REVIEW OF WASTE PACKAGE VERIFICATION TESTS
BIANNUAL REPORT

NUCLEAR WASTE MANAGEMENT DIVISION
DEPARTMENT OF NUCLEAR ENERGY, BROOKHAVEN NATIONAL LABORATORY
UPTON, NEW YORK 11973

Prepared for the U.S. Nuclear Regulatory Commission
Office of Nuclear Materials Safety and Safeguards
Contract No. DE-AC02-76CH00016

The potential of WAPPA, a second-generation waste package system code, to meet the needs of the regulatory community are analyzed. The analysis is based on the contents of the code manual, a letter-form update of the code and, to a lesser extent, on the source program. The analysis includes an in-depth review of WAPPA's individual process models and a review of WAPPA's operation. The analysis lists and discusses potential problems in the use of WAPPA. It is concluded that the code is of limited use to the NRC in the present form. Recommendations for future improvement, usage, and implementation of the code are also given.

Figure 2.2 Geometrical representation of the waste form as a line source surrounded by the engineered barriers of the waste package.

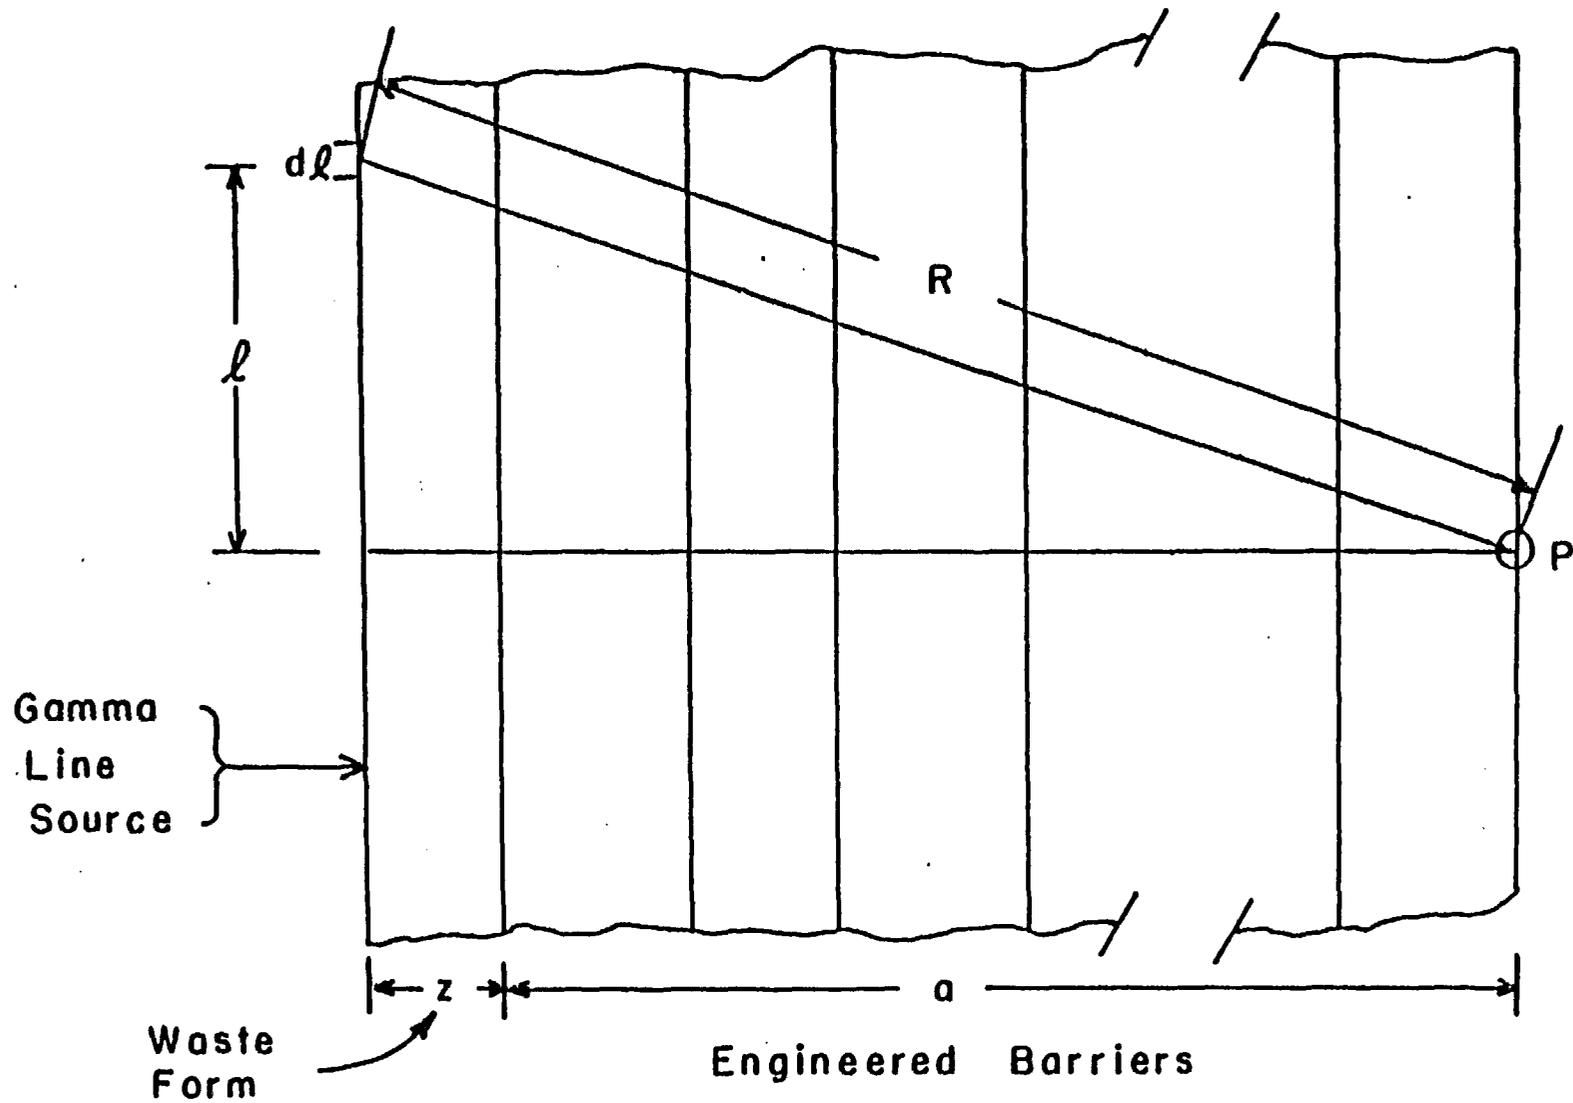
However, WAPPA calculates the buildup factor based on the normal distance between the line source and point P, the distance $a+z$ in Figure 2.2. Because $(a+z) < R$ and the buildup factors increase with distance, this assumption is non-conservative. Heuristic arguments (Sullivan, T., MF-142, 1984), indicate that the calculated flux will be within a factor of 10 of the flux obtained using the distance R in calculating the buildup factor. Considering the uncertainties in the entire calculation and the fact that corrosion or leaching are expected to be enhanced by less than 20 percent for an order of magnitude increase in gamma dose, this error may not be significant, but it should be addressed in the code manual.

Figure 2.3 Typical waste form and canister design (adapted from AESD-TME-3131, 1982).

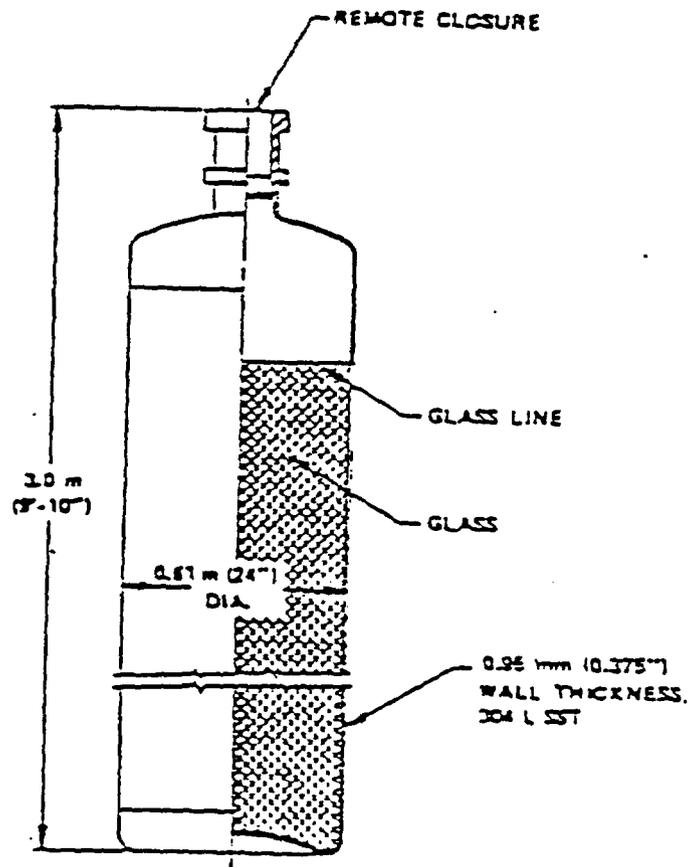
With reference to Figure 2.3, which reports a typical waste package design for high-level waste (AESD-TME-3131, 1982), it appears that a weak area in the canister structure is the neck area. In that area the metal is not supported by the waste form and the neck shape favors concentration of stresses. Thus, crushing of the air gap appears to be an important failure mode which ought to be addressed. Stresses may also concentrate at the bottom of the canister at the welds between the base and the rest of the metal, thus causing the base to detach. This failure mode should also be addressed.

Figure 2.4 Schematic representation of oxide thickness versus time. WAPPA considers thickness as a function of temperature and time.

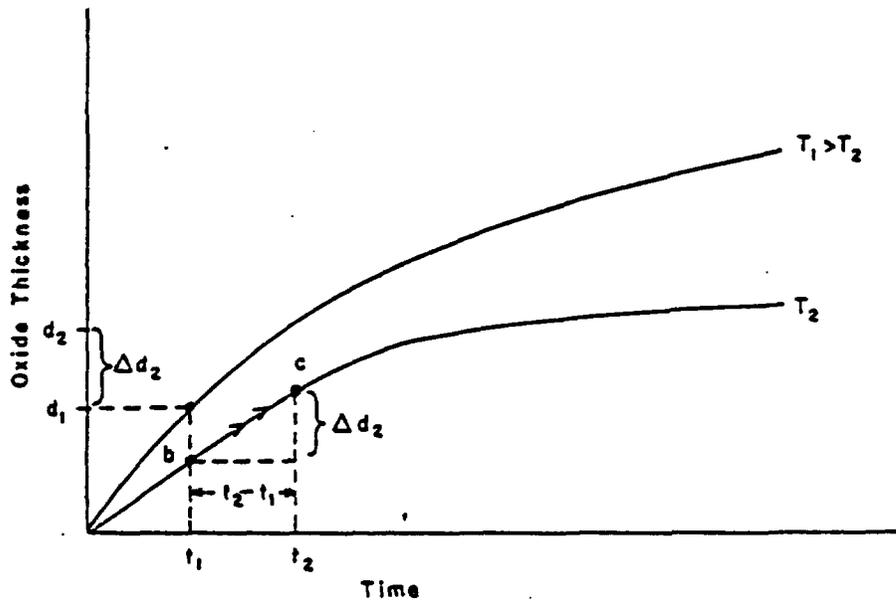
The method of solution used in WAPPA for calculating oxide thickness is most easily understood while viewing Figure 2.4, a plot of oxide thickness versus time for two temperatures. For the initial time step, time zero to time t_1 , the system is at temperature T_1 and the oxide grows to a depth, d_1 . In the subsequent time step, time t_1 to time t_2 , the system temperature has been updated and is T_2 . WAPPA calculates the incremental oxide growth, Δd_2 , as the amount of growth that would have occurred over the time interval t_2-t_1 provided the system had been held at temperature T_2 for the entire calculation time. This growth is represented by the curve through points b and c on the graph. The total oxide thickness is obtained by summation of d_1 , the oxide thickness and Δd_2 , the incremental growth. Viewing each time step as a new initial value problem, it is seen that the WAPPA code changes the "initial condition" for oxide thickness at each time step. Since growth rate is a function of thickness, this procedure is incorrect.

Figure 2.5 Improved oxide thickness calculation considers thickness as a function of temperature and previous history.

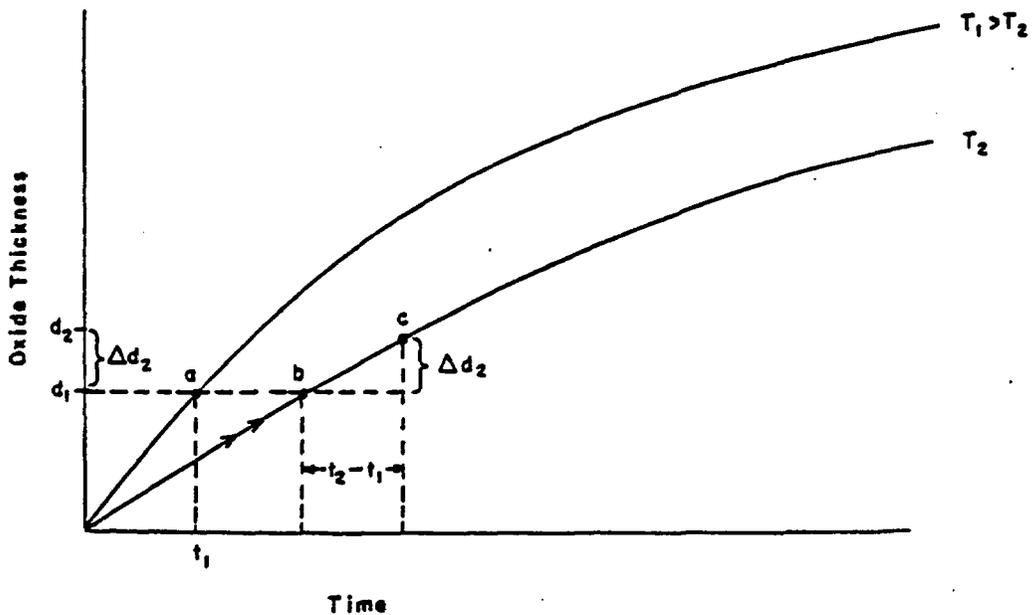
A better solution procedure is schematically represented in Figure 2.5. Here, after the oxide has grown to a depth d_1 at temperature T_1 , time is advanced to the next time step and the temperature is updated and is T_2 . In this case, growth of the oxide is calculated starting from a depth d_1 on the isothermal curve for temperature T_2 . This is point b in Figure 2.5. Growth

Figure 2.7 Initial configuration of the waste package in WAPPA's complex verification test case.

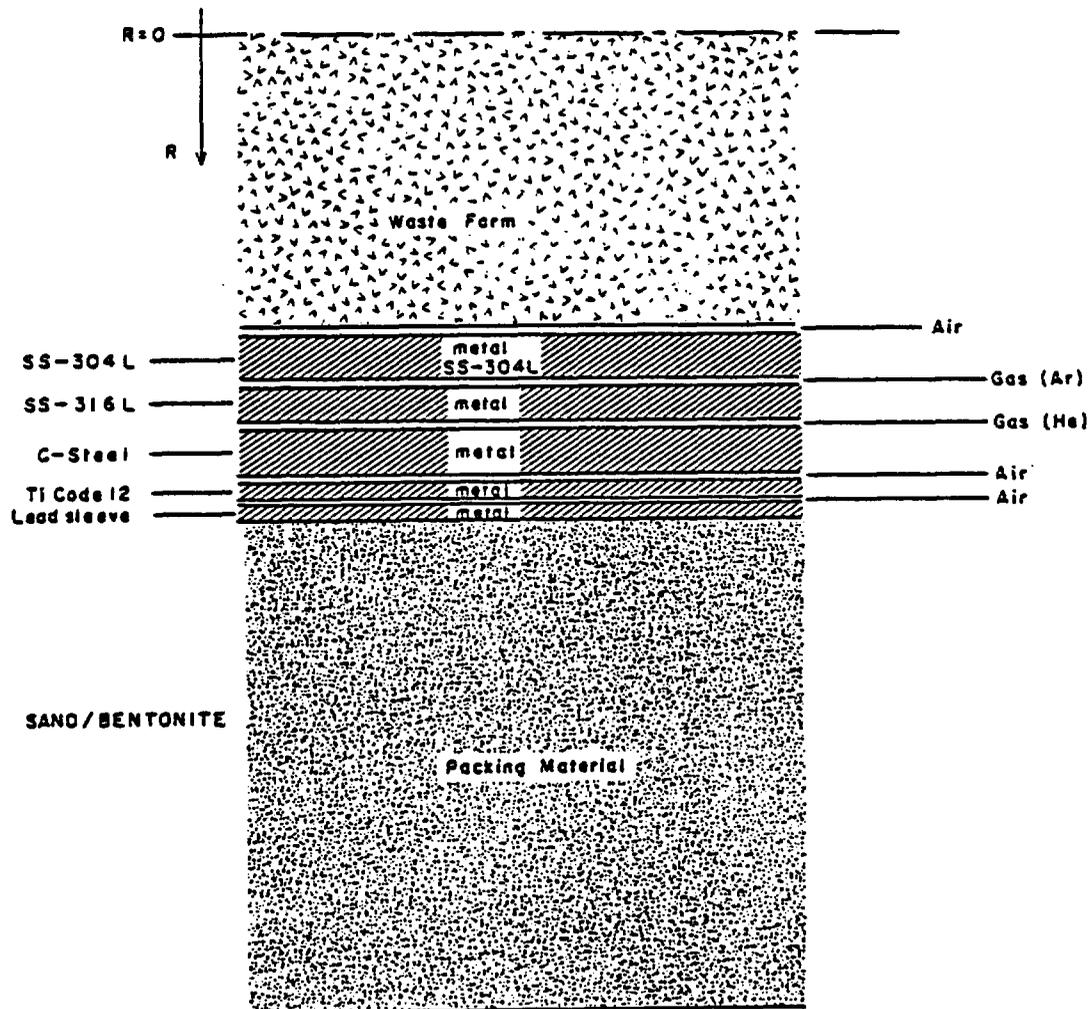
Allowable barriers are waste forms, metals, corrosion films, gases and packing materials. There can be 17 barriers at most; one waste form, one packing material, and five each of the other barrier materials. The materials reported in Figure 2.1 were inferred from Chapter 2 in the code manual. As a general comment, the test listing does not provide a key to the identification of each particular material constituting the waste package barriers. For instance the listing leaves one uncertain as to whether the waste form is glass or spent fuel.
